Lower Thames Crossing

**The Examining Authority's Written Questions and Requests for Information (ExQ2) –
Thurrock Council Responses**

31 October 2023

Application by National Highways for the Lower Thames Crossing The Examining Authority's written questions and requests for information (ExQ2) Issued on 10 October 2023

Figure 1 Location of additional planned developments along the A128

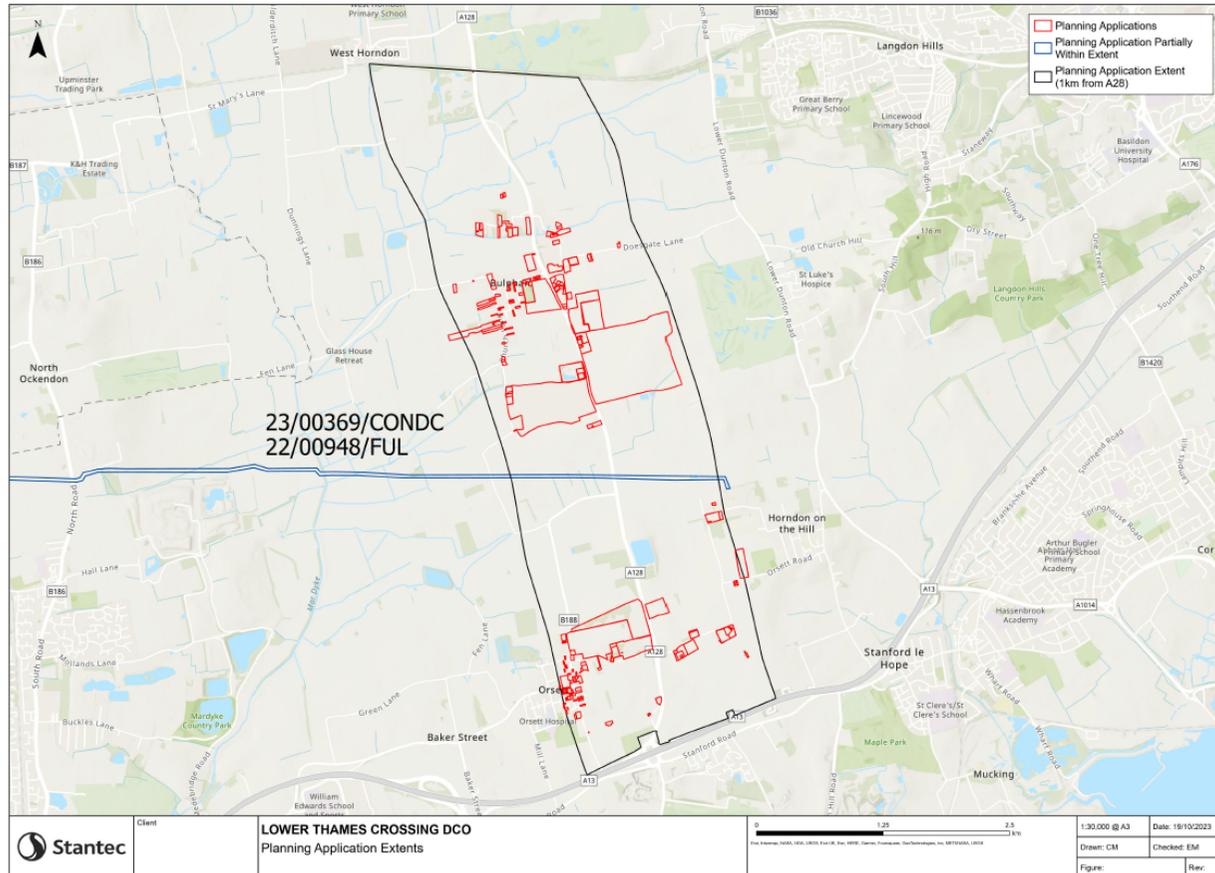
The additional planned developments within 1km either side of the A128, north of the Orsett Cock Junction are show in **Figure 1** below.

These developments are presented in **Appendix 1**, which describes their stage in the development process (e.g. planning application submitted, planning permission granted, under construction, etc.).

Plate 4.3 Development locations in Dartford, Gravesham and Thurrock

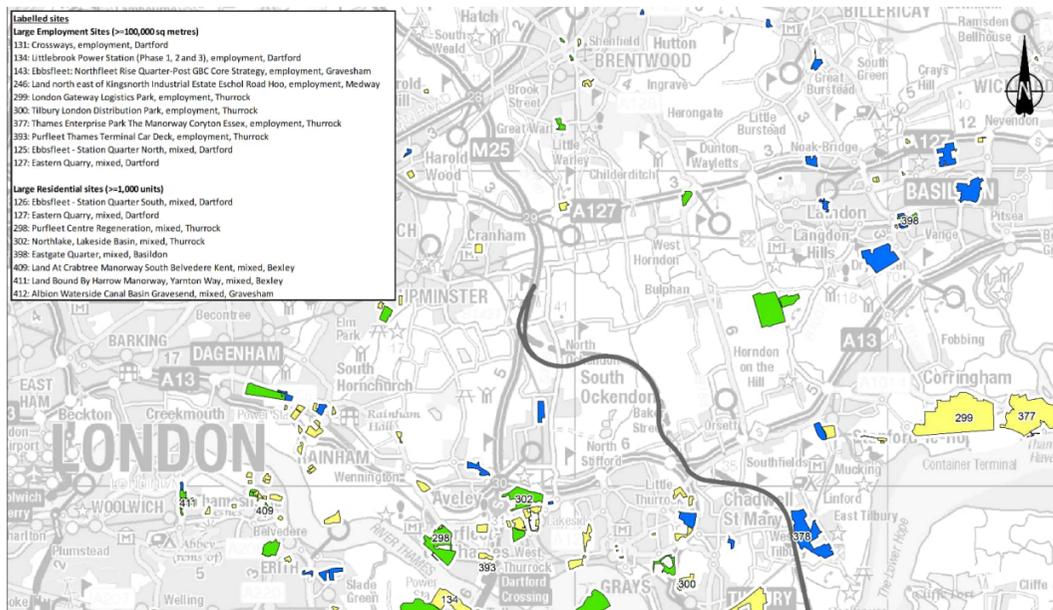
Both the LTAM and VISSIM models prepared by the Applicant for the A13/A1089/Orsett Cock junction make assumptions around the level of traffic growth associated with development that can be expected by the opening year (2030) and the design year (2045) of LTC. The assumptions around new development therefore affect the traffic forecasts for the 'without LTC' and 'with LTC' scenarios. Appendix C, Plate 4.3 of the Combined Modelling and Appraisal report ([APP-522](#)) shows the development assumptions included in LTAM. This is repeated below for convenience.

This diagram shows that the developments presented in Appendix 1 are not assumed within the LTAM model, although in practice the traffic generated by these developments can be considered to be covered by the assumed growth in trips related with the application of NTEM. The new developments

ExQ2	Question to:	Question:
<p>presented in Appendix 1 that may have a significant effect on traffic flows is small in number (a crematorium, a Road Planning Depot and car park and housing development of just over 150 dwellings), when coupled with the likely future emerging Local Plan growth does mean that the associated increase in traffic flows could be beyond that assumed in LTAM and this provides further support for the introduction of a monitoring and mitigation strategy at the Orsett Cock junction (and beyond).</p> <p>The applicant has recently issued new version of the VISSIM model on 6 and 20 October and the Council provides initial comments on these revised models and their 'convergence' with LTAM in its report: 'Thurrock's Council's Comments on applicant's Submissions at Deadline 4 (D4) and Deadline 5 (D5)', dated 31 October 2023.</p> <p>Summary: the Council has provided the required list of additional planned developments along the A128 north of the Orsett Cock junction and has provided comments regarding the likely effects of the emerging Local Plan. The cumulative effect of the expected new developments along the A128 could lead to an increase in traffic flows at the Orsett Cock junction beyond the traffic flows levels currently assumed in LTAM and VISSIM models of the Orsett Cock junction and leading to additional congestion and delay. The list of new developments that may have a significant affect on traffic flows and the likely emerging Local Plan growth provides further support for the introduction of a monitoring and mitigation strategy at the Orsett Cock junction.</p>
